RE: Township of Havelock- Belmont- Methuen  
Contract No. 2026-01  
Reconstruction of County Road 48 (George Street)  
**Addendum No. 3**

Please find outlines below a detailed summation of which forms Addendum No.2, of which shall form and become part of the Contract Tender Documents.

TYPICAL ROAD CROSS SECTIONS

DRAWN BY: BND PROJECT NO: 220-5178  
 DESIGNED BY: BND DATE: APRIL 2026  
 CHECKED BY: PS SCALE: HORIZONTAL - 1:50 VERTICAL - N/A  
 APPROVED BY: PS CONTRACT NO: -- DRAWING NO: CS-02

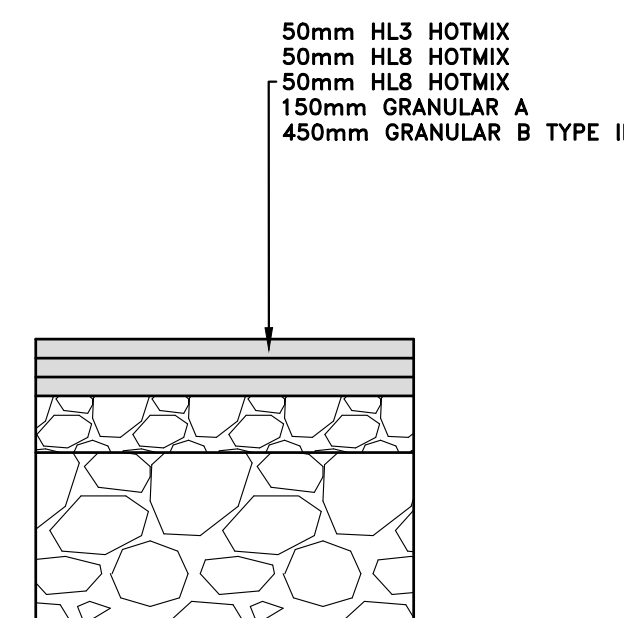
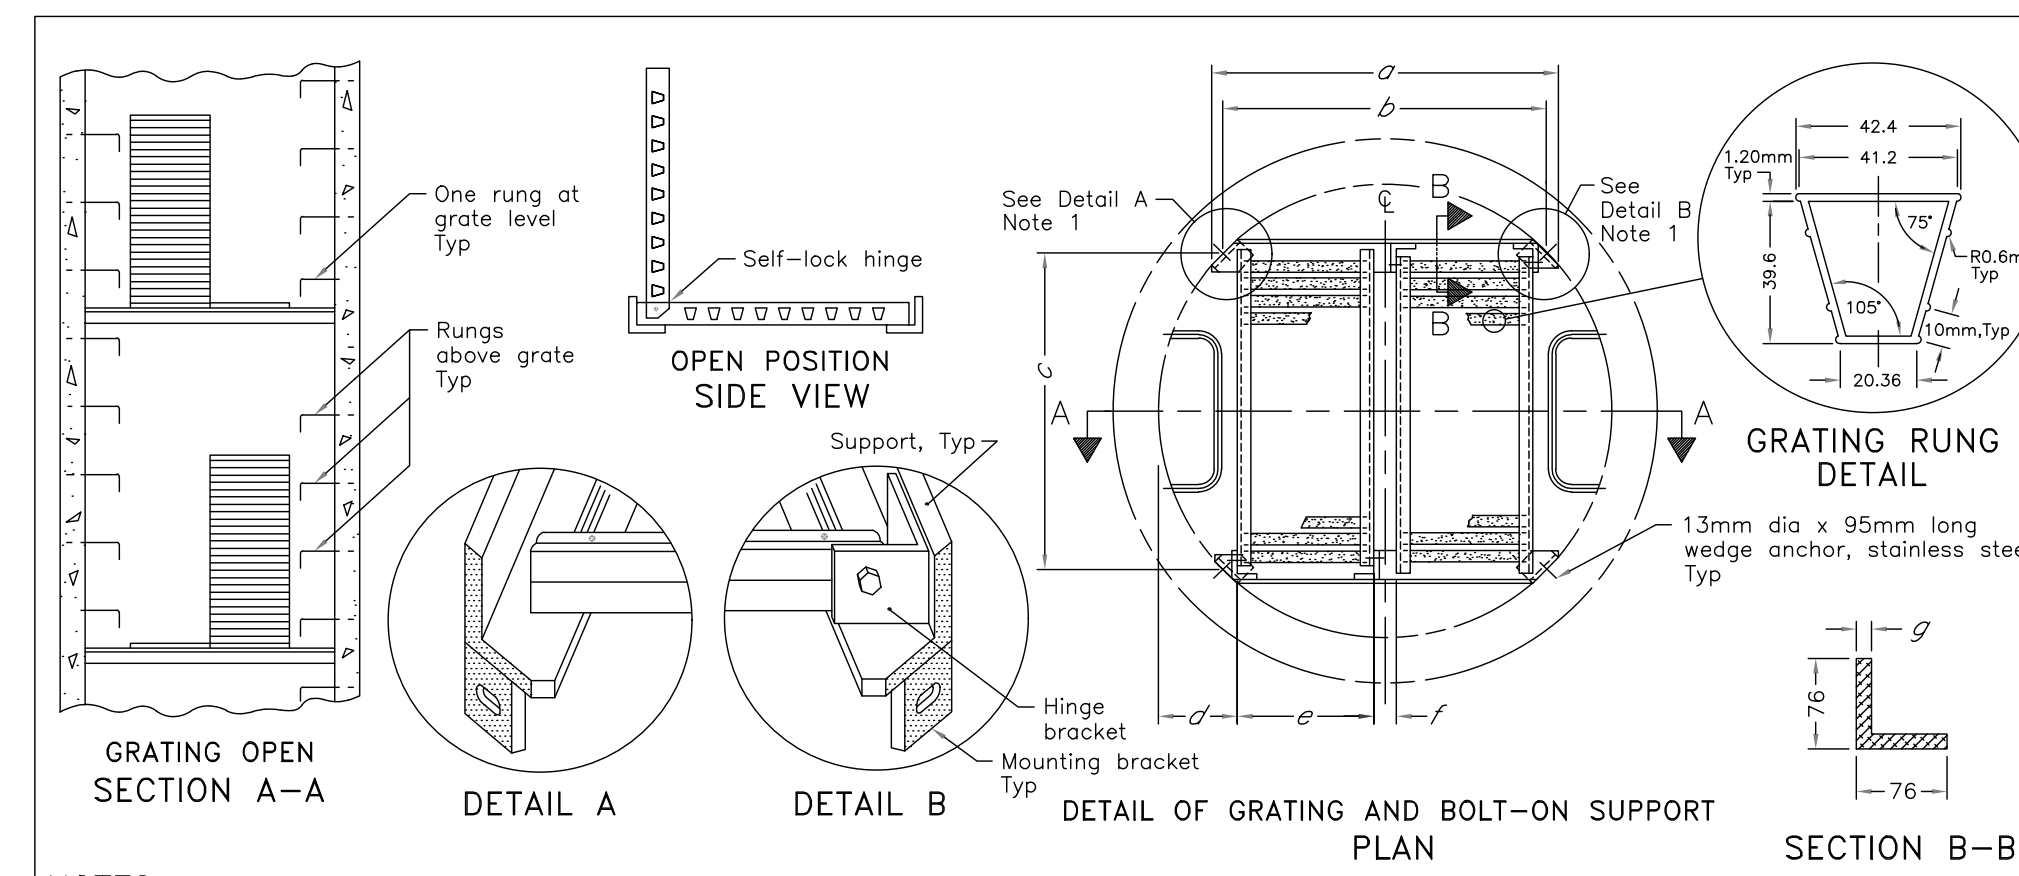
Q4 - Please provide the proposed Pavement Structure for the work out on Hwy No. 7 at William Street.

Q5 - Please provide a cross section of the proposed Pavement Structure for the work on Willam Street.

**A4 – Please see revised Drawing CS-02.**

**A5 - Please see revised Drawing CS-02.**
